Revision	Date	Description	Initial	Checked
1	04/03/19	ISSUED FOR DA MODIFICATION	BS	DOMA

**42 Honeysockle Drive,  
Newcastle**  
General Arrangement Plan  
Ground Floor

Status	SKETCH
Scale	1 : 150 @ A1
Drawn	BS
Checked	DOMA
Project No.	s12109
Plot Date	29/03/2019 5:25:27 PM
Plot File	42HONEYSUCKLEDRIVE_ARCH
Drawing no.	SK.03.101
Revision	1

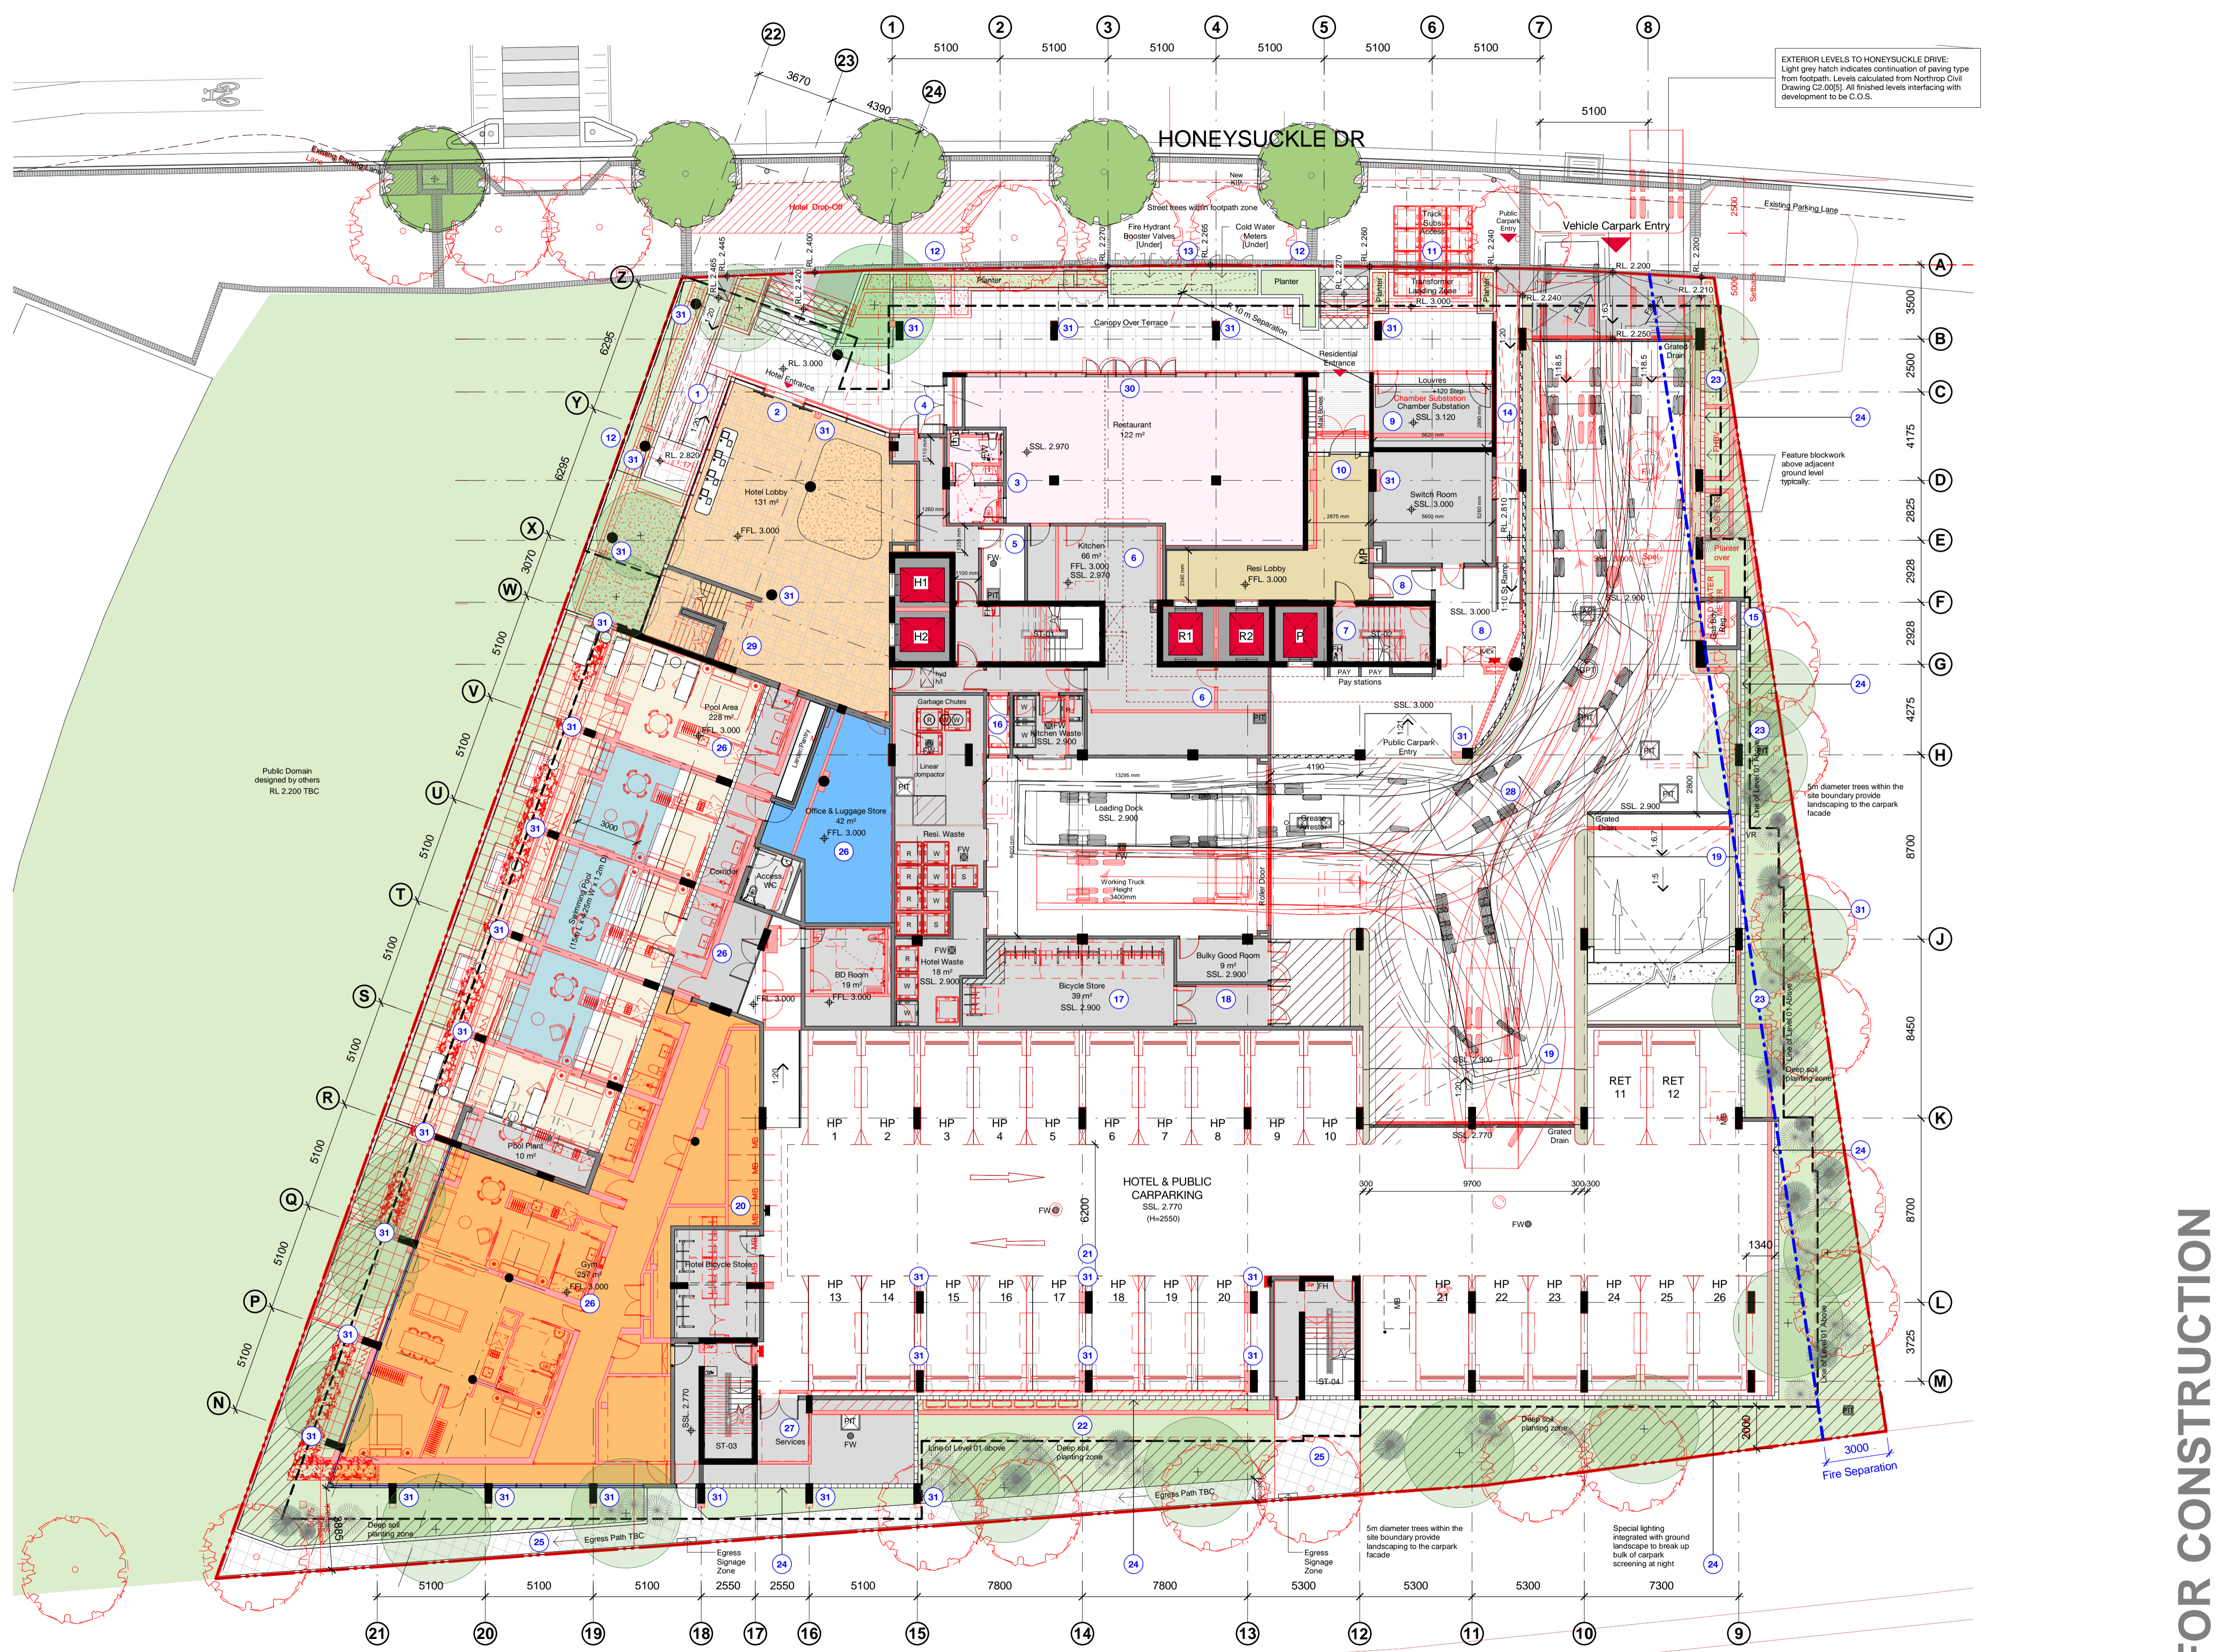
- Ground Floor**
- Hotel entry ramp adjusted to suit more gentle slope.
  - Hotel entry glazing line setback and egress entry moved over.
  - Restaurant WC and vestibule mirrored.

- Fire Brigade Panel cupboard located at NW corner of restaurant in lieu of Fire Control Room.
  - Sprinkler Control Valves located to north of Stair ST-01.

- Store rooms deleted. Restaurant Kitchen extends modified.
  - Stair ST-02 flipped. Egress direct to Resi. Lobby.
  - Public Entry Lobby east of Stair ST-02 modified.

- Chamber Substation moved south. East wall extended north.
  - Resi. Lobby - Entry setback and corridor widened.
  - Transformer Landing Zone modified. Bin setdown deleted.

- Planter box arrangement modified along Honeysockle Drive.
  - FHBV and Cold Water Meters relocated to Honeysockle Drive.
  - Pedestrian access ramp layout modified.

- Gas Boundary Regulator moved.
  - Airlock added between Compactor Room and Kitchen Waste Room.
  - Bicycle Store - Rack layout updated.
  - Bulky Good Room extent modified.

- Carpark ramp extends modified.
  - 5 x Motorbike parks deleted. 1 x MB moved east of Stair ST-04.
  - 6 x Hotel Parking spaces moved east.
  - Condenser zone between grids 13-16 (South carpark) relocated.

- Facade modified to suit.
  - Eastern facade extends between grids A-K modified.
  - Facade materiality modified along East and South facade. Feature blockwork in lieu of concrete walls.

- Egress path from Stairs ST-03 and ST-04 modified.
  - 7 x Serviced Apartments deleted between Grid N-W. Replaced with Swimming Pool and Gymnasium. Structure, landscaping, circulation arrangement, wet areas and office space modified to suit.

- Services room modified between grid 15-18 (South carpark).
  - Portion of carpark between grid E-K lowered to SSL 2.900. Ramps affected modified to suit.

- Common Area Stair between grids W-X widened.
  - Restaurant glazing line setback.
  - Column moved/modified.

**42 Honeysuckle Drive, Newcastle**  
General Arrangement Plan Level 03

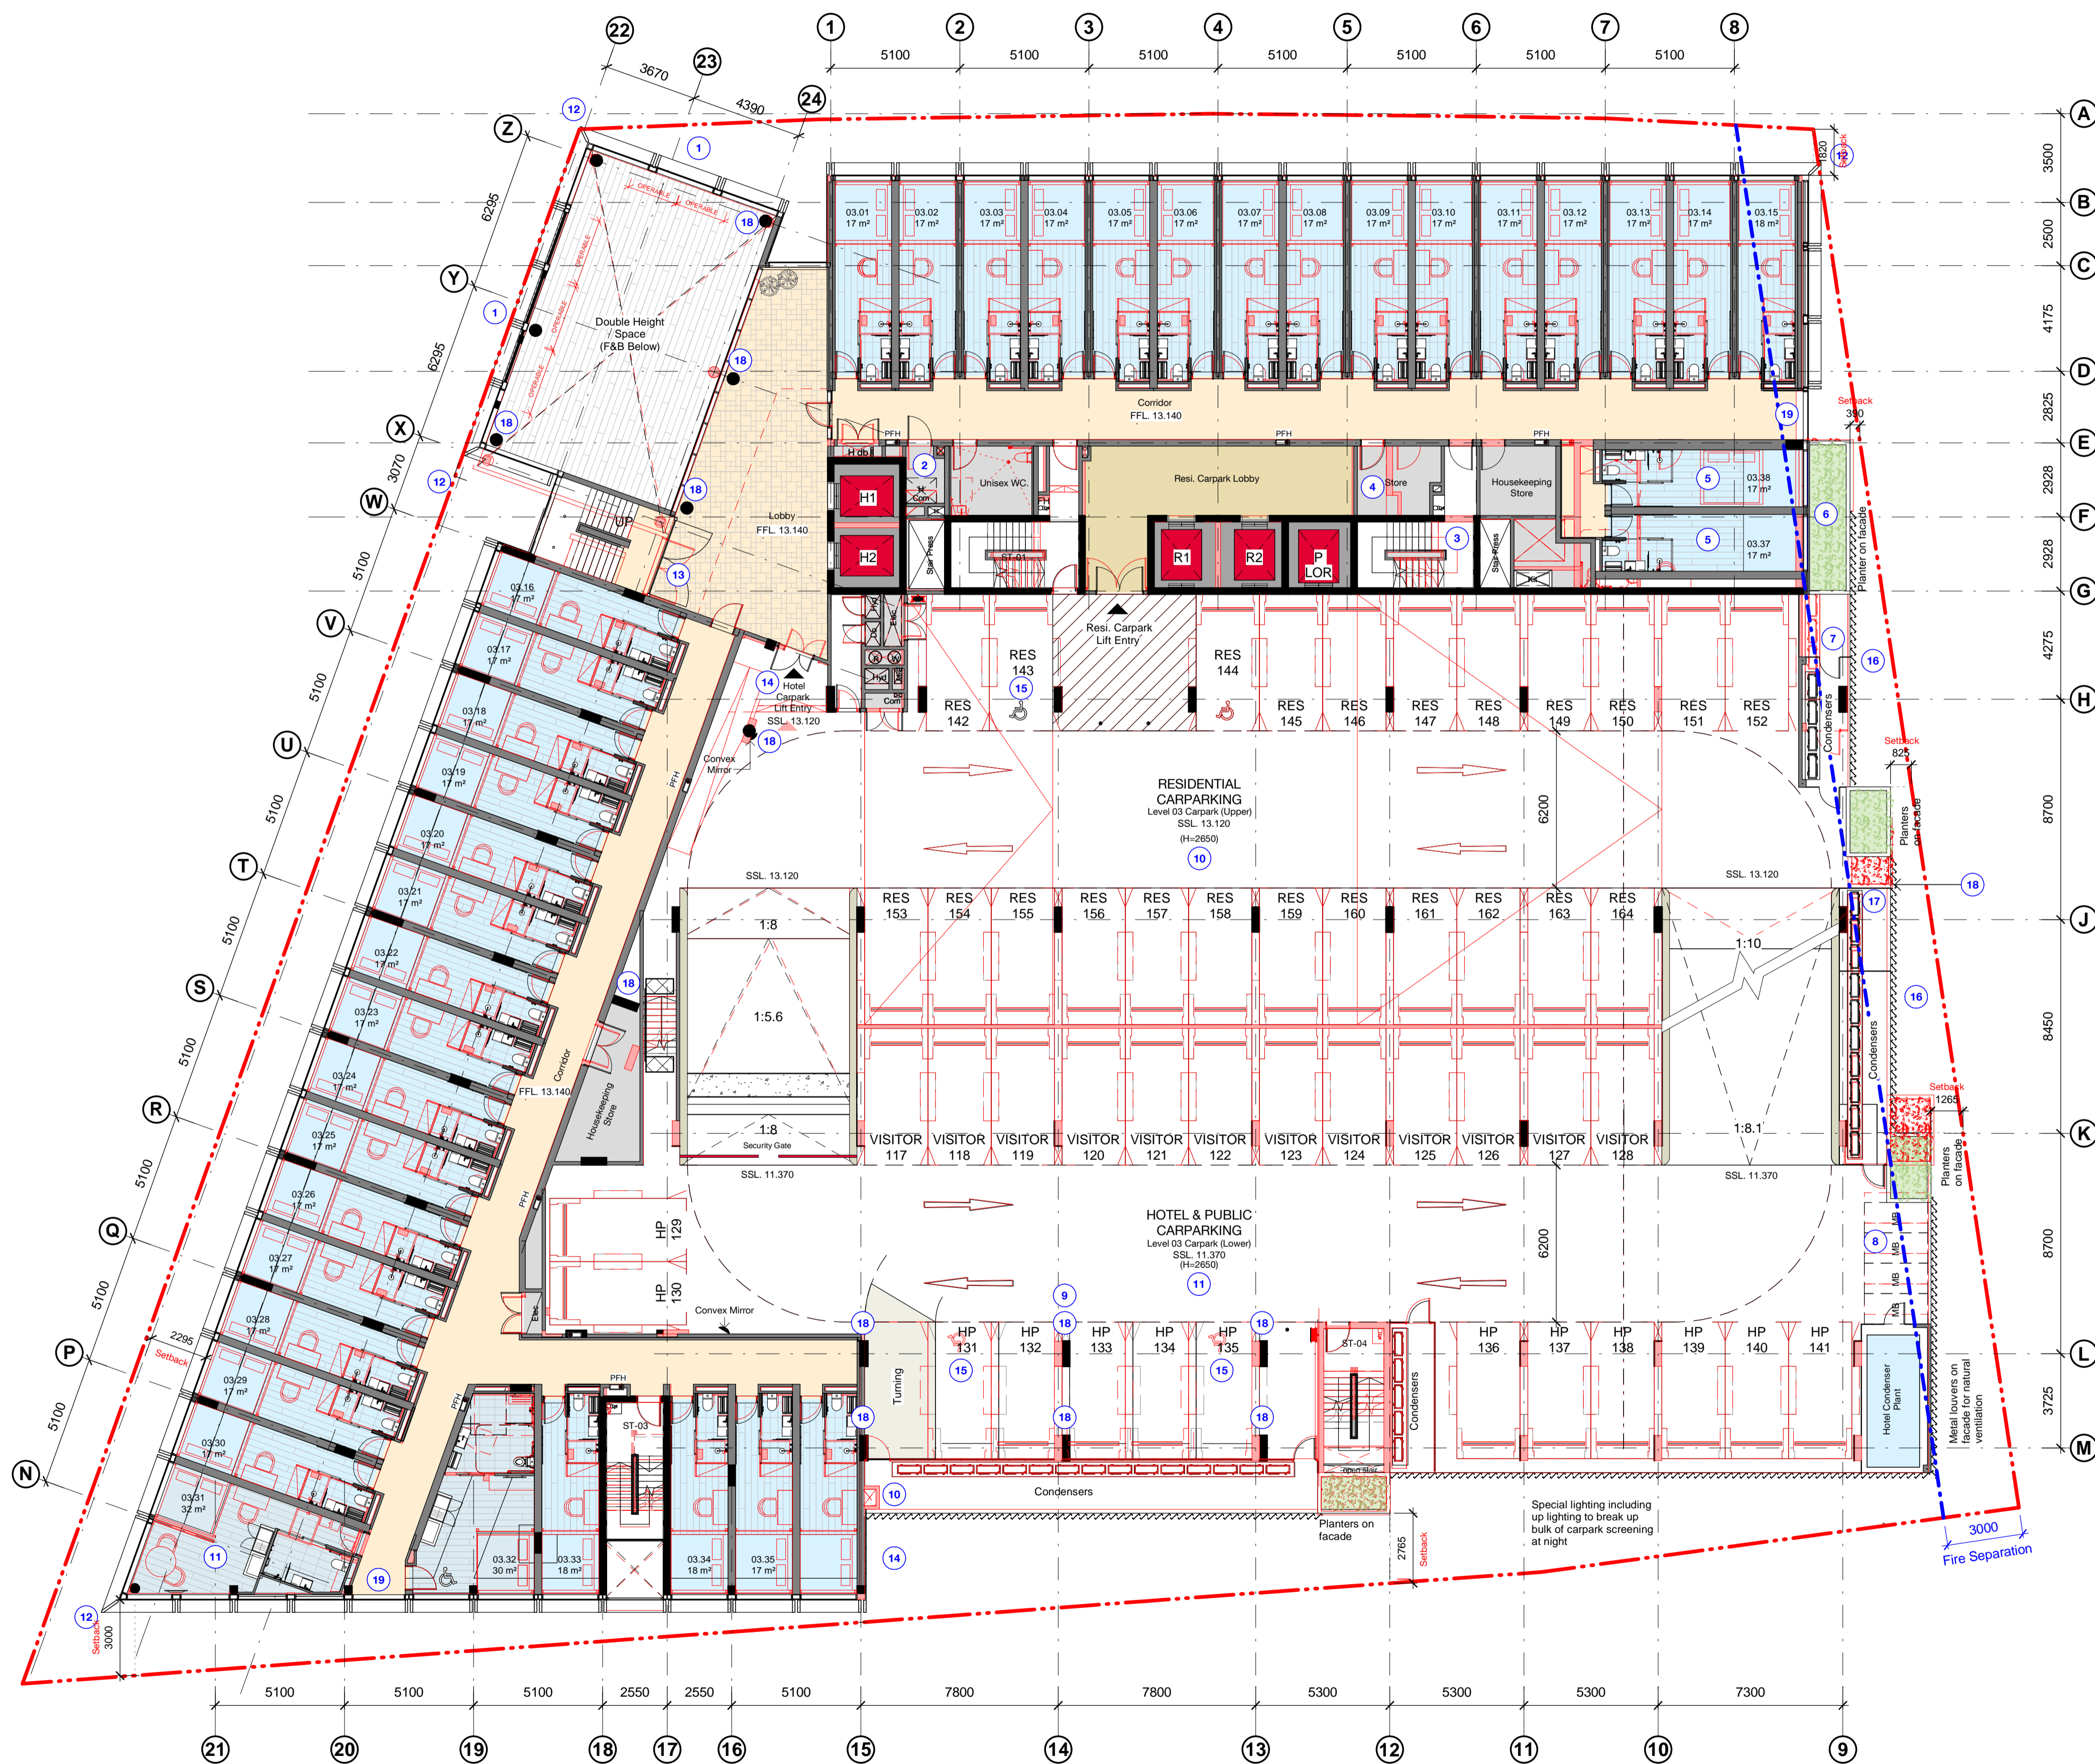
- Level 03**
1. Facade articulation modified to NW/NE Common Area
  2. Service room behind Hotel lifts modified.
  3. Stair ST-02 mirrored.
  4. Store room north of Stair ST-02 modified.

5. 2 x Additional Hotel rooms provided in lieu of Access. Hotel room.
  6. Exterior facade between grid E-G (East carpark) modified to suit 2 x additional Hotel rooms.

7. Condenser zone (East carpark) at grid H modified to allow maintenance access for planter box.
  8. Motorbike parks between grids K-L (East carpark) shifted.

9. 6 x Parking spaces between grids 13-15 moved east.
  10. Riser at grid 15 (South carpark) deleted.
  11. Hotel room at SW corner redesigned.
  12. Facade fin corner detail modified.

13. Common Area Stair between grids W-X widened.
  14. Entry from carpark (Upper) into Hotel lobby modified. Stair and ramp deleted.
  15. Parking space typology rearranged.

16. Eastern facade extents between grids F-K modified.
  17. Condenser zone (East carpark) between grids J-K modified.
  18. Column moved/modified.
  19. Fixed glazing system to corridor end in lieu of louvred system.
